AGENDA
HISTORIC PRESERVATION BOARD
Lakeland City Hall, City Commission Chambers
March 26, 2026, 8:30 A.M.

**HISTORIC PRESERVATION BOARD
DESIGN REVIEW COMMITTEE
STAFF REPORT
March 26, 2026**

Project #	HPB26-033
Project Type	Replacement Siding
Property Address; Historic Name	832 S. Central Avenue The Thomas and Lorraine Cain House (1952 Lakeland City Directory)
Historic District; FMSF#	Lake Hunter Terrace Historic District; #PO06383
Owner/Applicant	WHPH Investments LLC / Brad Wagner
Zoning District; Future Land Use; Context District; SPI	RA-3; Residential Medium; Urban Neighborhood
Existing Use	Residential
Adjacent Properties	Residential
Previous Approvals	Minor Exterior Alterations, 11/5/2025 (HPB25-210)

Project #	HPB26-037
Project Type	Exterior Alterations: New Siding and Replacement Windows
Property Address; Historic Name	1107 Biltmore Place Jackson and Helen Harris House (Lakeland City Directory 1950)
Historic District; FMSF#	Biltmore-Cumberland Historic District; #PO06576
Owner/Applicant	Savannah Osteen / Heart in Home Construction, Steve Blake
Zoning District; Future Land Use; Context District; SPI	RA-3; Residential Medium; Urban Neighborhood
Existing Use	Residential
Adjacen

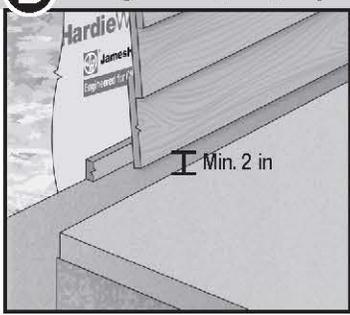
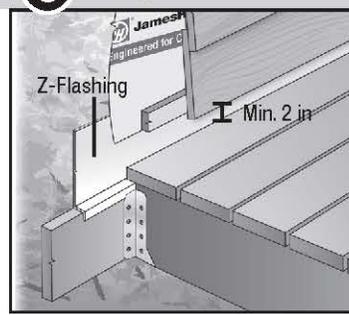
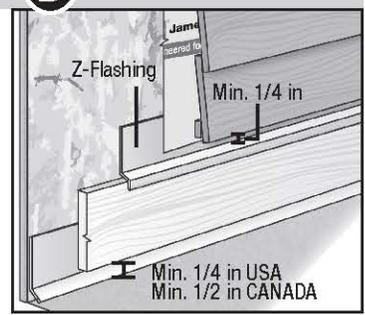
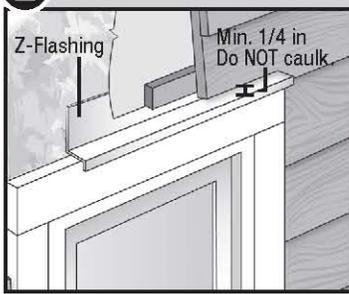
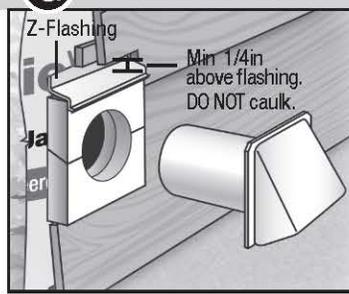
While the repair or replacement of small areas of siding may be reviewed and approved by staff, the wholesale replacement of all exterior wall cladding requires the review and approval of the Design Review Committee.

Staff finds that fiber-cement lap siding is an acceptable replacement for standard wood lap siding according to the Design Guidelines. However, as the James Hardie company does not produce a lap siding with the Dutch lap profile, staff recommends repairing the existing siding or replacing the siding with wood siding matching the Dutch lap profile instead of using the Hardieplank lap siding.

1. Denial of the request as submitted.
2. Final approval of wood replacement siding that matches the Dutch lap profile and dimension of the existing siding and trim, or repair of existing siding and trim with matching material.
